SS 1034579 WST Rocore Cooler (07-23256-001) Premature Failures

All WST Models equipped with Allison Transmission and Rocore Transmission cooler (07-23256-001) with tow pin front X-member

Old Rocore Cooler 07-23256-001

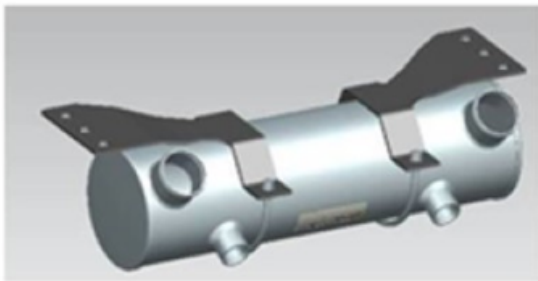
Rocore coolers 07-23256-001 are failing prematurely

There is a new stainless steel cooler offered in Pargon (07-25266-000). This cooler is a direct replacement cooler and requires no modifications or plumbing changes. (see illustration below)

NOTE: The new stainless cooler will become standard with new builds in early 2020 as a permanent solution. This Service Solution will be updated at that time.
